Access Compliance Report

Public Rights-of-Way

(Curb Ramps)

Intersection ID: 7629	Main Street: AMBLE_DR	Cross Street: PEBBLE_ST	Location: SW
ADA ID: 770936645474	Ramp Type: Perp	Initial Pass/Fail: Fail	Overall Compliance: No
Severity Score: 26.25			
Codes/Mitigation Info/Possible Solution		Field Measurements/Component Compliance

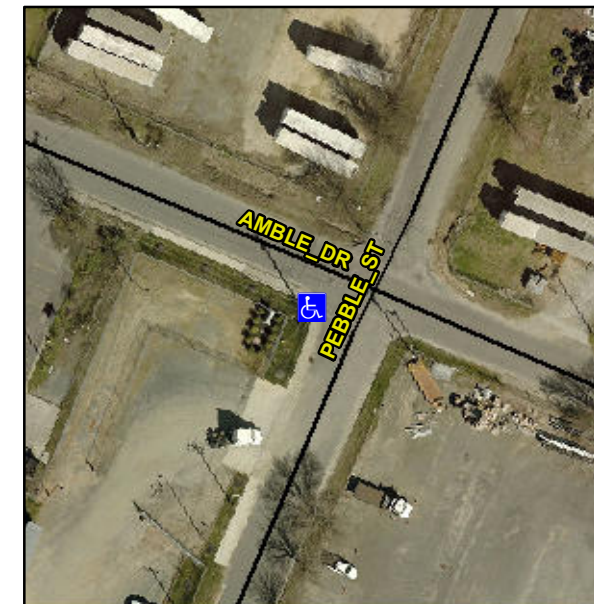
Not Found, R304.2.2

Compliance	Description	Data	Compliance	Description	Data
N/A	Ramp Length (in)	49.0	No	Ramp Slope (%)	13.0
Yes	Ramp Width (in)	60.0	Yes	Ramp XSlope (%)	3.1
N/A	Flare Type LT	N/A	N/A	Flare Type RT	N/A
N/A	Flare Slope LT (%)	N/A	N/A	Flare Slope RT (%)	N/A
N/A	Flare Traversable LT?	N/A	N/A	Flare Traversable RT?	N/A
N/A	Landing Length (in)	N/A	N/A	DWS Provided?	N/A
N/A	Landing Width (in)	N/A	N/A	DWS Contrast?	N/A
N/A	Landing Slope (%)	N/A	N/A	DWS Length (in)	N/A
N/A	Landing X Slope (%)	N/A	N/A	DWS Full Width?	N/A
N/A	Landing Curb? (Y/N)	N/A	N/A	DWS Offset (in)	N/A
N/A	Shared Landing?	N/A			
N/A	Gutter Ponding?	N/A	N/A	Gutter Slope (%)	N/A
N/A	Gutter Lip Ht (in)	1.0	N/A	Gutter X Slope (%)	N/A
N/A	Painted X Walk1?	No	N/A	Painted X Walk2?	N/A
	X Walk 1 Direction	To NE		X Walk 2 Direction	N/A
N/A	X Walk 1 Width (in)	N/A	N/A	X Walk 2 Width (in)	N/A
	X Walk 1 Slope (%)	2.6		X Walk 2 Slope (%)	N/A
	X Walk 1 X Slope (%)	8.4		X Walk 2 X Slope (%)	N/A

Remove & Replace Entire Ramp.
